Appln No. 10/562,171
Amdt. Dated August 6, 2008
Response to Office Action of February 6, 2008
Annotated Sheet # 1

Appln No. 10/562,171
Amdt. Dated August 6, 2008
Response to Office Action of February 6, 2008
Annotated Sheet # 2

Fig. 2

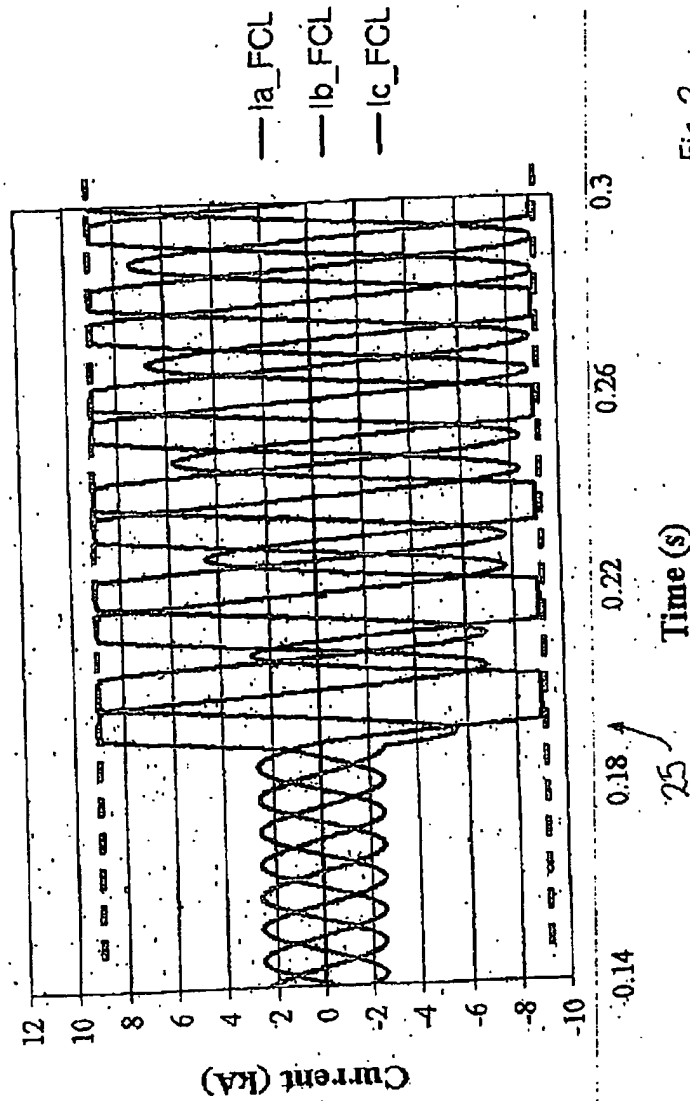
PRIOR ART

added →
